SIB 51 36 19

GROANING OR RATTLING NOISE COMING FROM FRONT OF TRUNK AREA

E-Series	Model Description	Production Date
G20	3 Series Sedan	Up to June 25, 2019

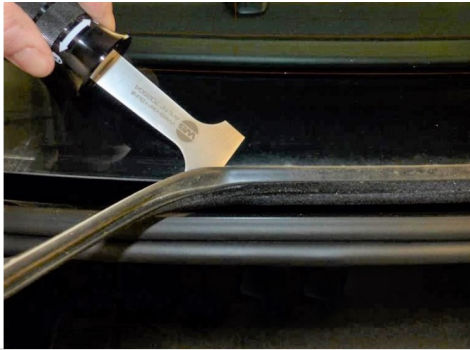
A groaning or rattling noise can be heard coming from the rear window acoustic seal area, where the seal meets the trunk lid. The noise can be heard while driving on rough roads, especially when the trunk space has been expanded by lowering the rear seat backrests.

The affected seal runs along the bottom of the rear glass as indicated below.

The trunk lid rubs against the seal and causes a noise when there is any movement.

Remove the seal and discard. No replacement seal of any type is needed.

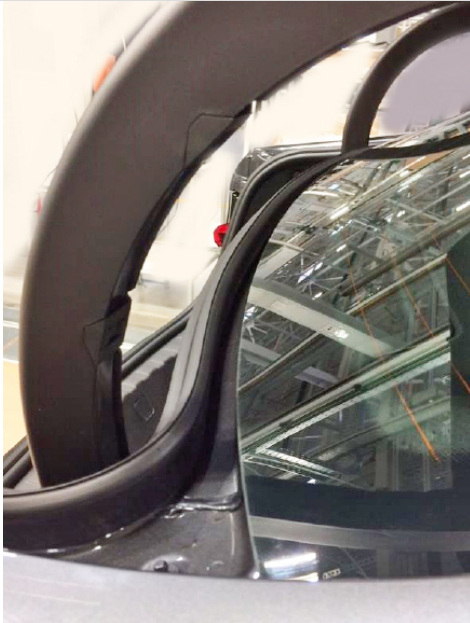
1. Gently pry the seal away from the glass.
  - Be careful not to gouge, chip or otherwise damage the rear glass

- Discard the seal

**Note: Later production vehicles do not have this seal installed, because the rear window bottom edge is sufficiently sealed.**

2. Remove any adhesive residue with cleaning agent R1 (83 19 2 211 217) or a suitable alternative.

The picture shows the seal completely removed.
